Remote Link and System Link

October 2010

Version 1.56 Software Update

Effective October 2010, Remote Link and System Link are being manufactured with Version 1.56 (10/14/10) to support the XTL, and XT30/XT50 Series Version 106 software.

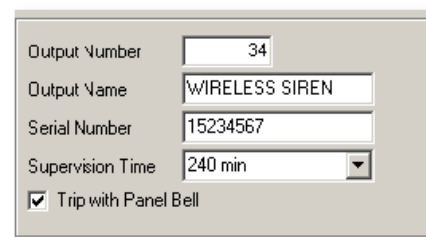
This section has been added to the XT30/XT50 panels to define the keypad configuration.

Device Number: Enter the address number of the devices you are adding to the system. The valid range is 1-8.

Device Name: Enter the name you wish to assign to the device. The name may be up to 16 characters long.

Wireless: Enable to use a wireless keypad for this device number. Disable to use a wired keypad for this device number. Default is disabled. You may install and address up to four wireless keypads.

Serial Number: This option only displays when Wireless is selected for this device number. Enter the eight-digit serial number found on the wireless keypad.

Supervision Time: This option only displays when Wireless is selected for this device number. Select the supervision time required for the wireless keypad. The wireless keypad must check-in at least once during this time or a missing condition is indicated for that device. Select 60 or 240 minutes. Select None for unsupervised operation. Default is 240 minutes.
